PNEUMATIC SYSTEM - NACELLE - POWERPLANT - TUBES, PRESSURE INDICATING - SERVO TUBE -
REPLACEMENT OF - CATEGORY CODE 4. - MOD.NAC-36-0001

V2500-NAC-36-0001

SERVICE BULLETIN

Replacement of the servo-tube
Fig.1

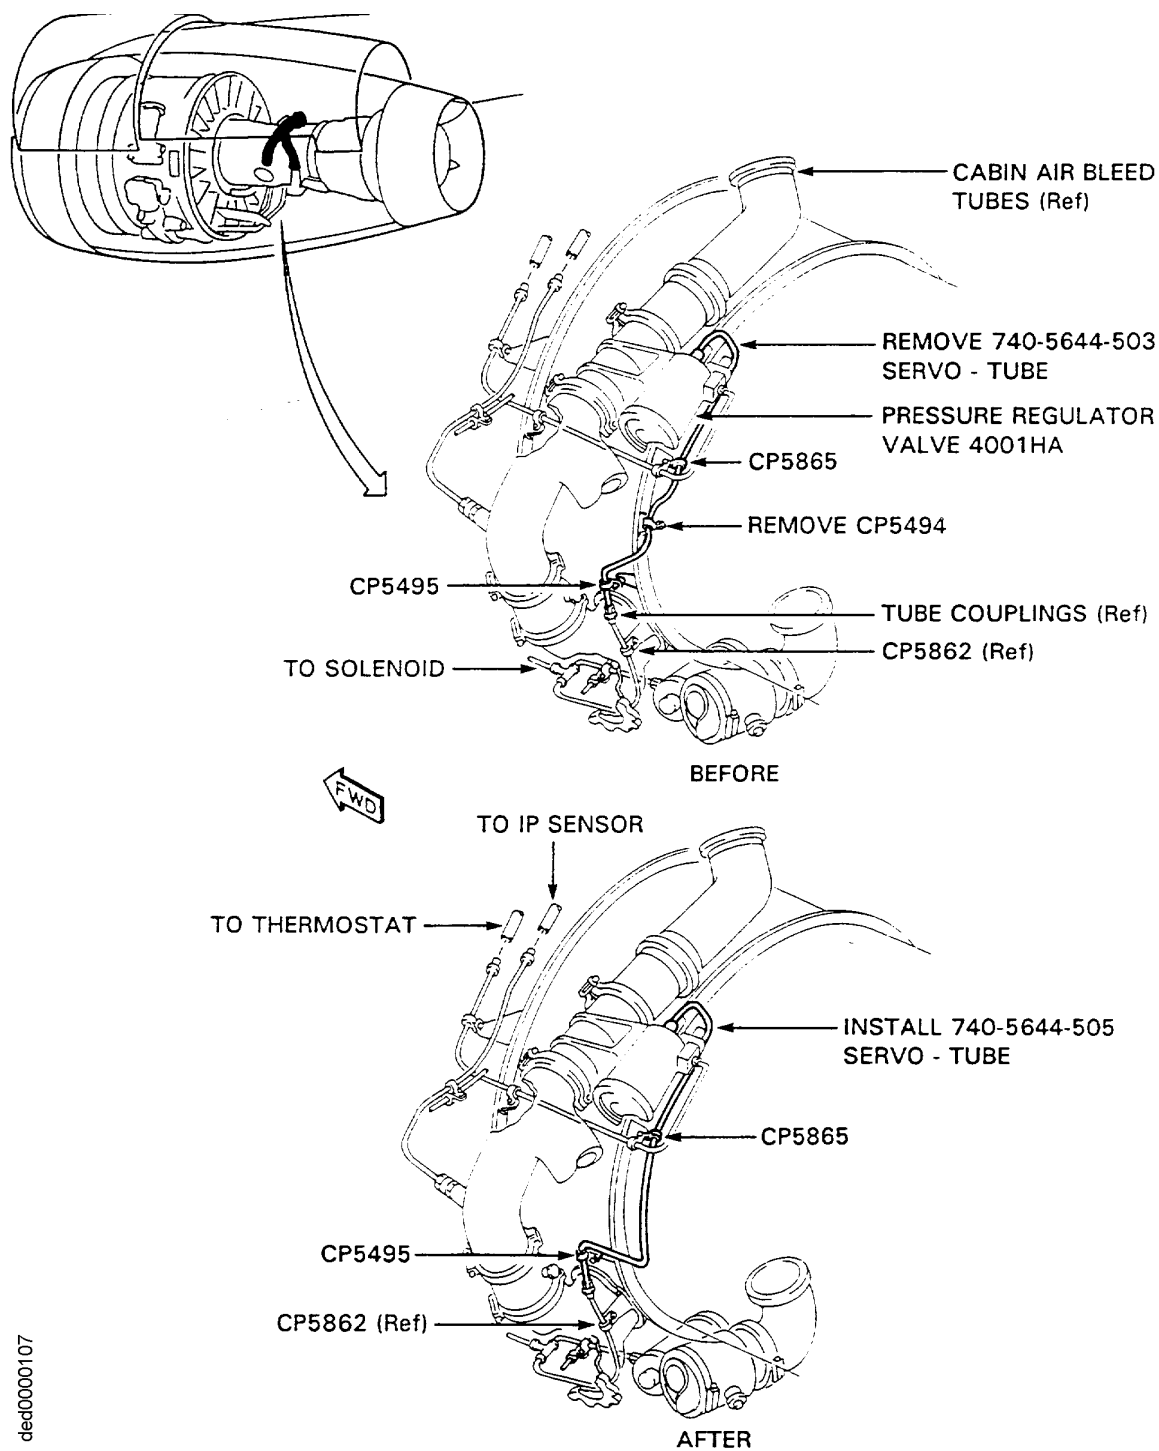
- (a) The servo tube to the bleed-air pressure regulator valve is replaced. Clipping points CP5865 and CP5495 are disassembled/ assembled to facilitate this and clipping point CP5494 (comprising bolt, nut and 'P' clip) is modified.

- (1) Open the left thrust reverser half with instructions in the A320 Aircraft Maintenance Manual, TASK 78-32-00-010-010.
- (2) Find the 740-5644-503 servo tube on the left side of the engine core (Refer to Figure 1).

- (1) Remove the two TA025022FT04 'P' clips, AS21406 bolt and AS41104 clip nut from the clipping point CP5865 (Refer to Figure 2).
- (2) Remove the TA025022FT04 'P' clip, AS20624 bolt, ST1698-D47 spacer and AS41104 clip nut from clipping point CP5495.
- (3) Remove the TA025022FT04 'P' clip, AS20624 nut and AS21406 bolt from clipping point CP5494. Discard the 'P' clip.
- (4) Reinstall the bolt and nut at clipping point CP5494. Torque the nut to 40lbf in (5,52 Nm).
- (5) Disconnect and remove the 740-5644-503 servo tube. Discard the tube (Refer to Figure 1).
- (6) Apply a small amount of high temperature anti-seize compound (CoMat 10-109) to the threads of the new 745-5644-505 servo tube.
- (7) Install the 740-5644-505 servo tube in the position of the -503 servo tube. Do not tighten the couplings at this time.

NOTE: It may be necessary and is permissible to carefully handform the tube at installation to eliminate any pre-load on the tube.
